From: [Patrick Byker](#)
To: [Jeff Kleaveland](#)
Cc: hornik@Broughlawfirm.com; "Wayne Hadler"; [Patricia J. McGuire](#)
Subject: Proposed Conditions for Sanderway CUP from Owners at 1242, 1244 and 1246 Hillsborough Rd
Date: Wednesday, October 10, 2018 4:51:09 PM
Attachments: [Sanderway Conditions as Revised by Owners at 1242 1244 1246 Hillsbor... .docx](#)
[Sanderway Conditions Exhibits A-C.pdf](#)

On behalf of the owners of 1242, 1244 and 1246 Hillsborough Road, attached please find our proposed conditions that we respectfully request the Board of Aldermen adopt in conjunction with the Sanderway AIS Conditional Use Permit. We have worked to incorporate comments from Mr. Hornik into these conditions, but we of course defer to his approval regarding the final wording of these conditions.

SANDERWAY
 EXHIBIT 'B'
 CARRBORO, NORTH CAROLINA

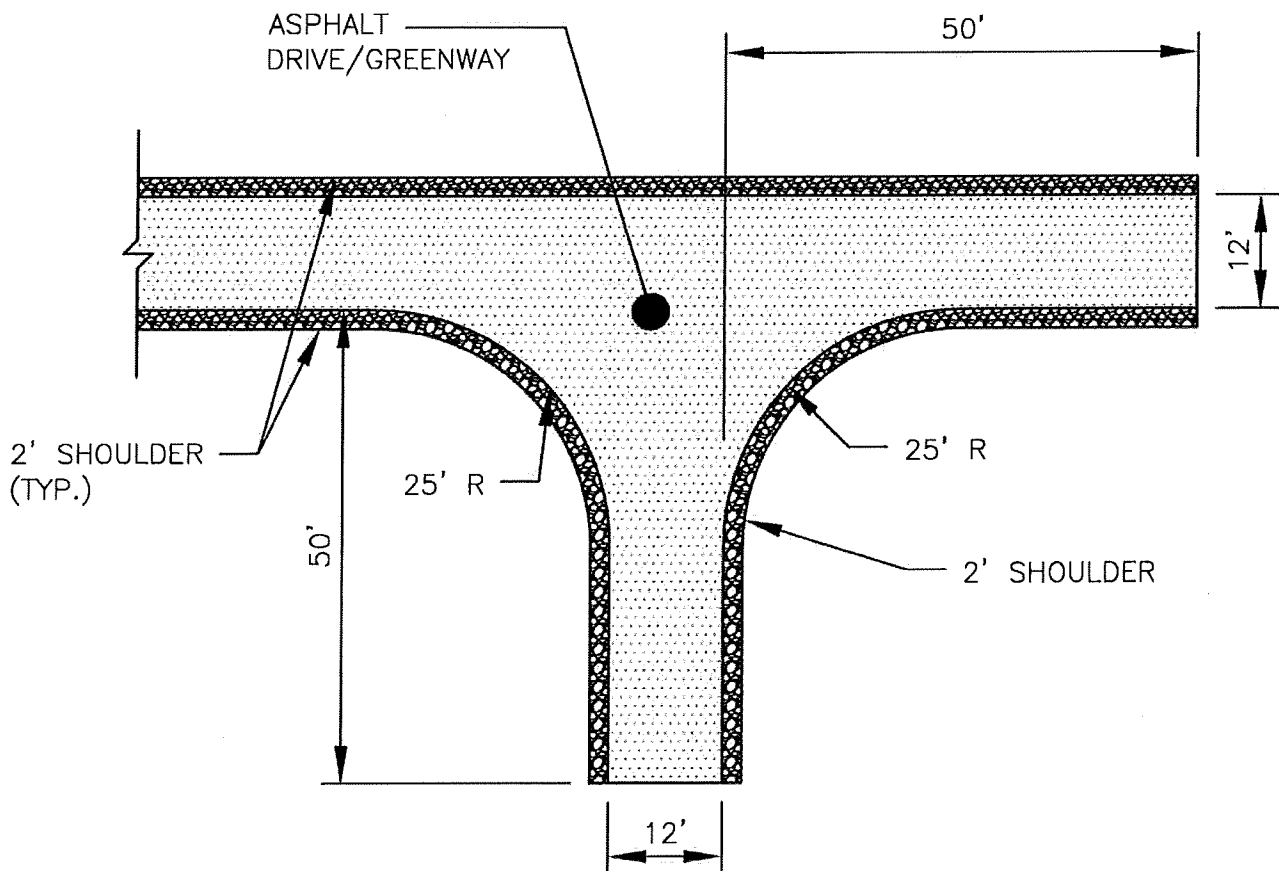
17. That during the construction process, and in perpetuity, continued accessibility for the three lots shall be maintained uninterrupted.
18. That the cross-section of the paved multi-use path referred to in Condition 16 shall be constructed to drain exclusively into the existing drainage ditch behind the Barrington subdivision and shall be twelve feet (12') wide with an eight inch aggregate base and two inches of asphalt with shoulders as shown in more detail on Exhibit B, which is attached hereto and incorporated herein by reference.
